Item Name: Quick Release Basket and Long Cargo Tube Mounting Provisions, Fits LH or RH

DART SERVICE INSTRUCTION

TO AMEND INSTALLATION INSTRUCTIONS D350-607-3 Rev.D,
INSTALLATION INSTRUCTIONS D350-607-4 Rev. C AND
INSTRUCTIONS FOR CONTINUED AIRWORTHINESS ICA-D350-607 REV. 6
REF TCCA STC: SH94-14
REF FAA STC: SR00213NY
REF EASA STC: EASA.10016996
REF BRAZILIAN STC: 2007S03-03/-04/-05/-06

A	NEW ISSUE	AJS	14.05.16
REV.	DESCRIPTION	BY	DATE
DESIGN	AJS	DART AEROSPACE LTD HAWKESBURY, ONTARIO, CANADA	
DRAWN	AJS		
CHECKED		DRAWING NO.	REV. A
MFG. APPR.	N/A	DSI 9699	SHEET 1 OF 2
APPROVED		TITLE	SCALE
DE APPR.		LUG REPLACEMENT	NTS
DATE	14.05.16	COPYRIGHT © 2014 BY DART AEROSPACE LTD THIS DOCUMENT IS PRIVATE AND CONFIDENTIAL AND IS SUPPLIED ON THE EXPRESS CONDITION THAT IT IS NOT TO BE USED FOR ANY PURPOSE OR COPIED OR COMMUNICATED TO ANY OTHER PERSON WITHOUT WRITTEN PERMISSION FROM DART AEROSPACE LTD.

FIGURE 1: INSTALLATION OF D4775-041 FWD STRUT

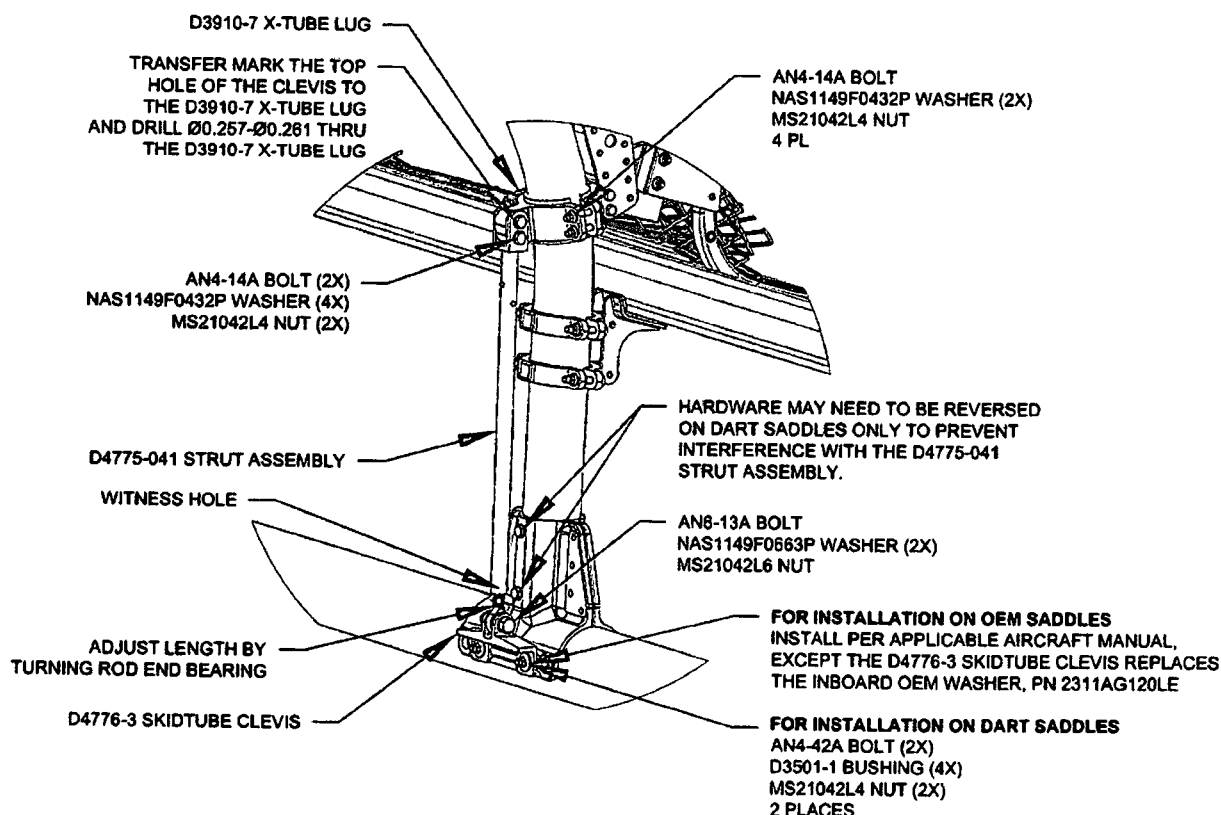
- 3.1 Substitute the Forward Lower D3910-5 X-Tube Lug with the D3910-7 X-Tube Lug as shown in Figure 1.
- 3.2 Install the forward D4775-041 Strut Assembly. Transfer mark from the upper hole on the clevis of the D4775-041 Strut Assembly to the D3910-7 X-tube Lug and drill thru the lug $\varnothing 0.257$ - $\varnothing 0.261$ as shown in Figure 1. Touch up chemical conversion coating per MIL-DTL-5541. Check the witness holes located at the bottom end of the D4775-041 Strut Assemblies to ensure that the thread from the rod end extends past the witness hole.
Torque MS21042L4/-4 nuts to 50-70 in-lbs (5.7-7.9 N-m). Torque MS21042L6/-6 nuts to 160-190 in-lbs (18.1-21.5 N-m).
- 3.3 Complete the installation in accordance with Installation Instructions D350-607-3 Rev. D or D350-607-4 Rev. C.
